24Hr Fitness Kirkland WA

CITY OF KIRKLAND BUILDING DEPARTMENT	
PERMIT #	SGN12-04949 PLAN CASE SGNPR12-0159
ADDRESS	12526 TOTEM LAKE BLVD, #A
WORK CLASS	NEW
PROJECT	
OWNER	24 Hour Fitness, Inc
DT SUBMITTED	12/27/2012
DT APPROVED	<i>[Signature]</i> 1/11/13
APPROVED BY

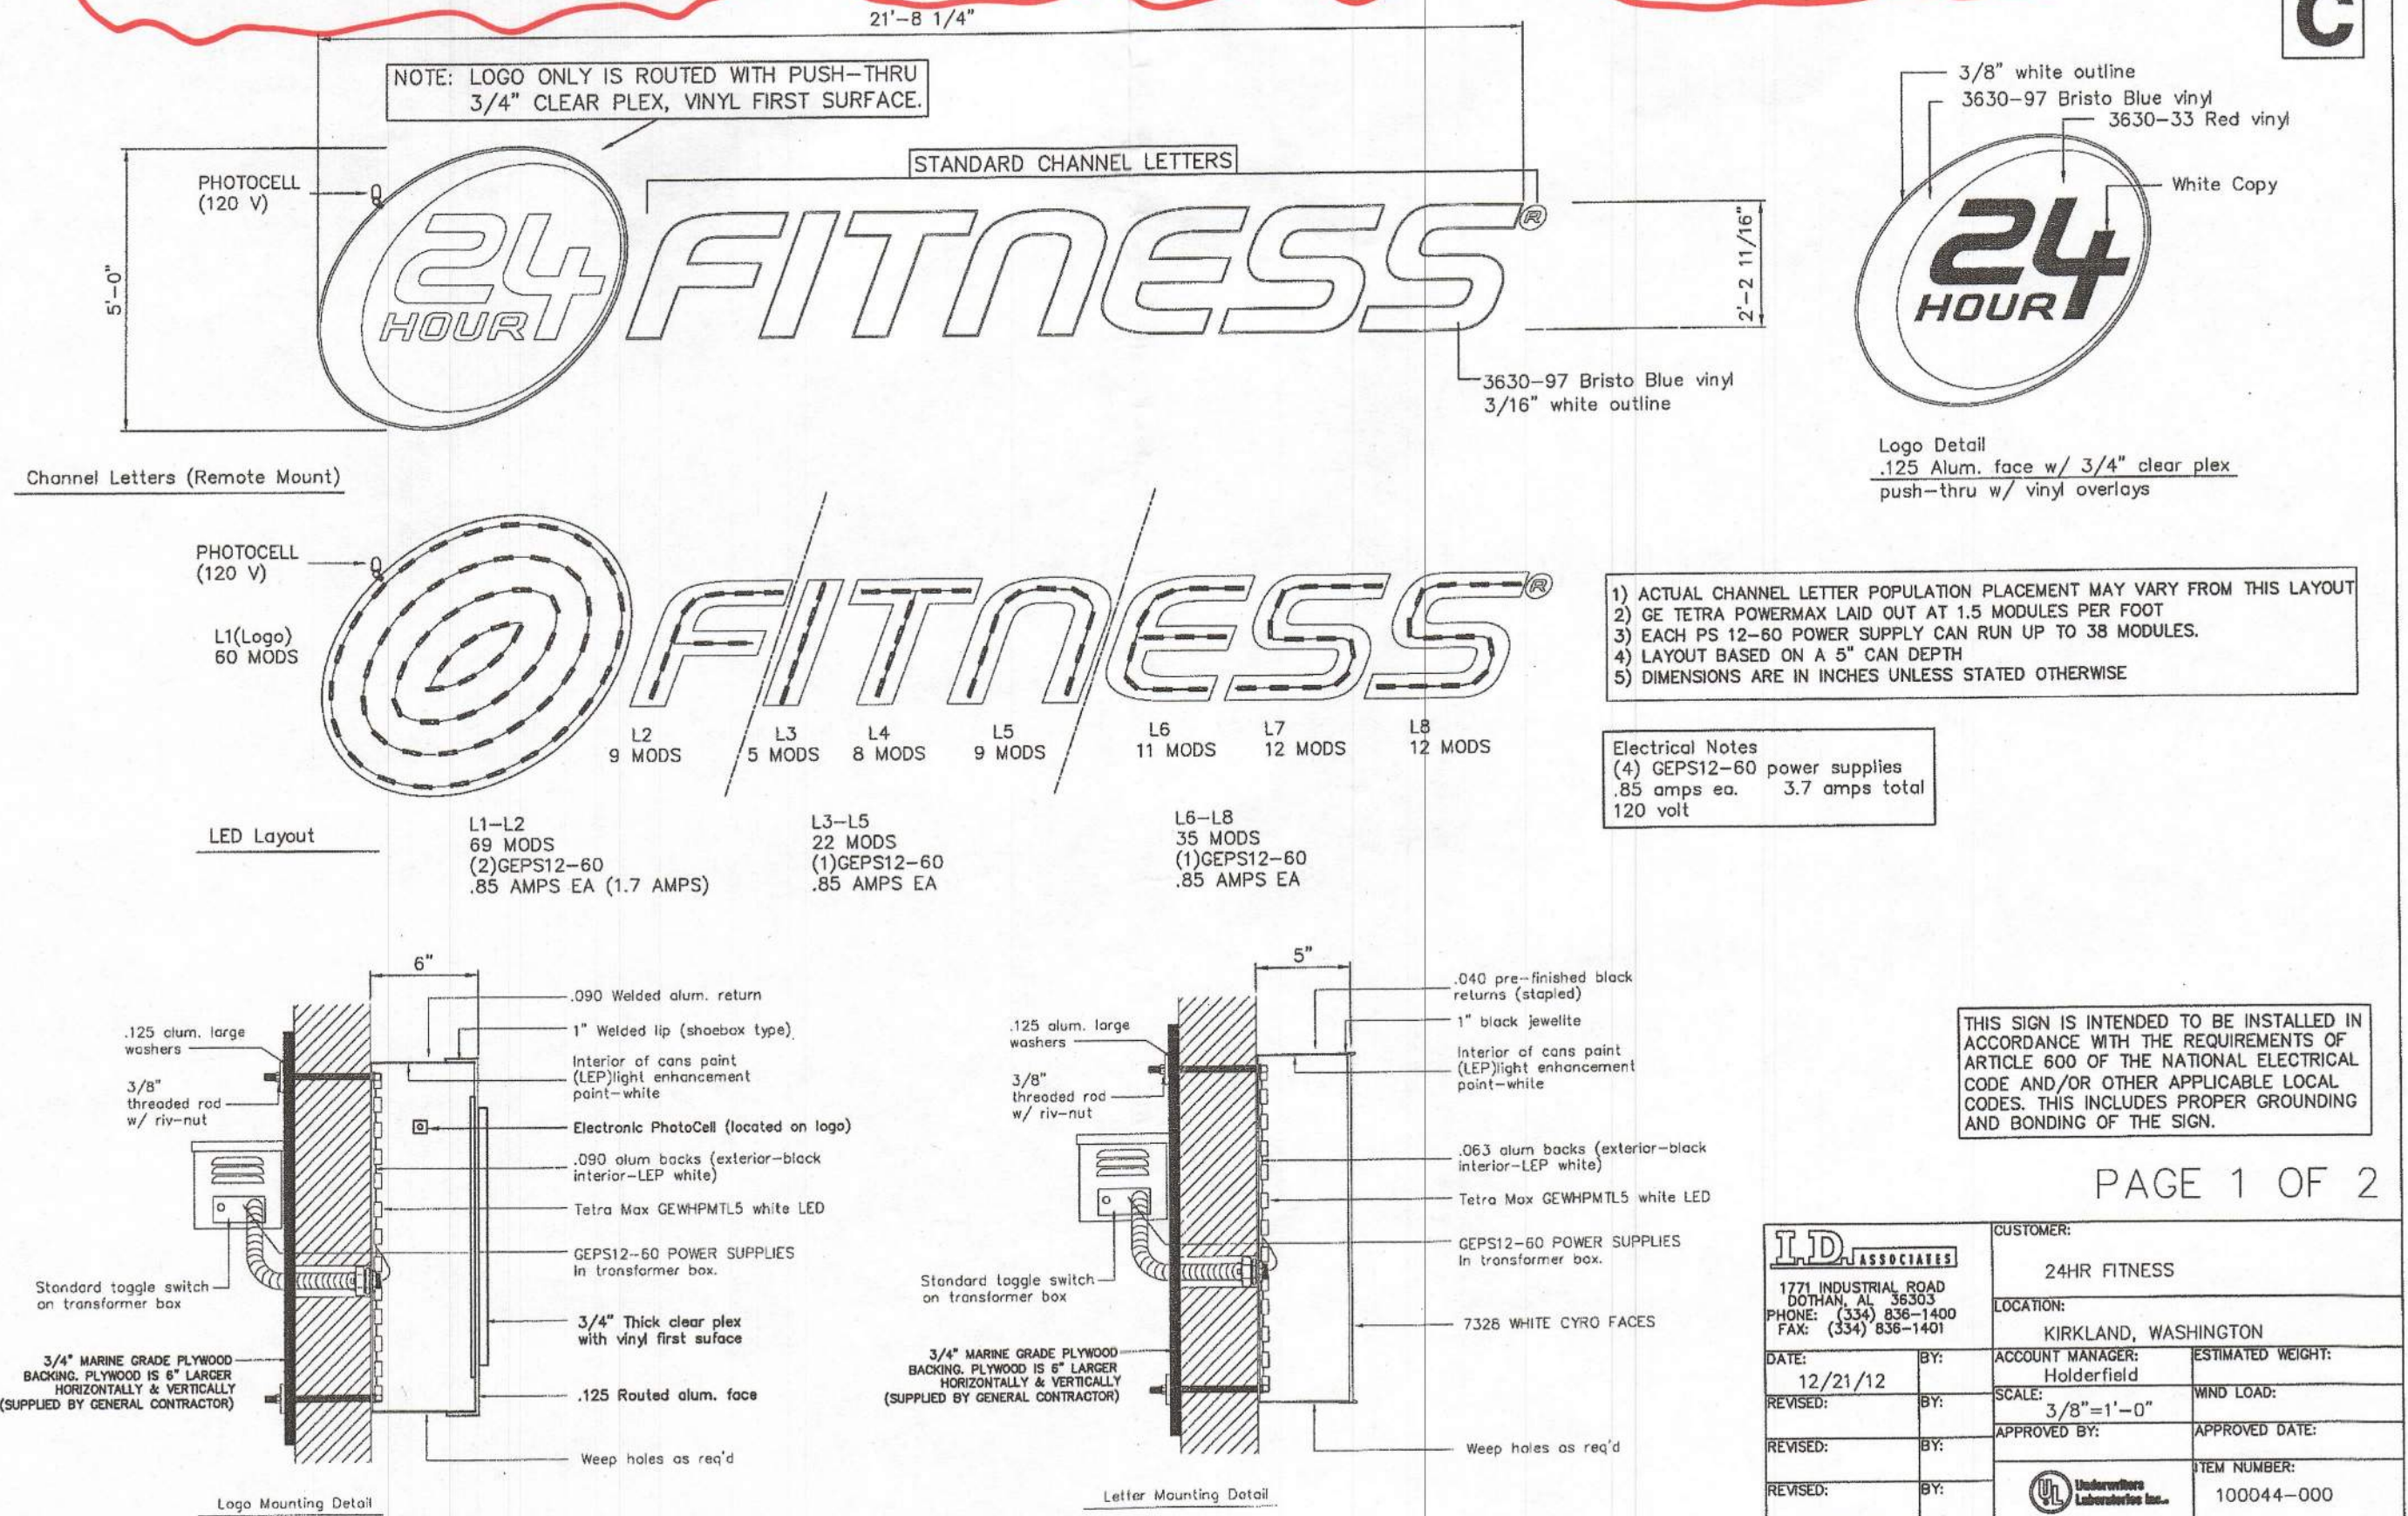
Smaller letters such as "I" need no less than 2-3 screws per letter to attach to the wall. All larger letters require no less than 4 screws per letter. Screws shall penetrate sheathing and shall be into framing or other substantial material.

CALL FOR ELECTRICAL AND
STRUCTURAL ATTACHMENT
ROUGH-IN INSPECTIONS
DURING INSTALLATION.

Electrically illuminated signs are required to be listed and labeled (such as UL listings). Listed equipment has been listed and identified by a laboratory approved by the State of Washington for appropriate equipment standards. Labeled equipment bears a certification mark issued by a laboratory accredited by the State of Washington.
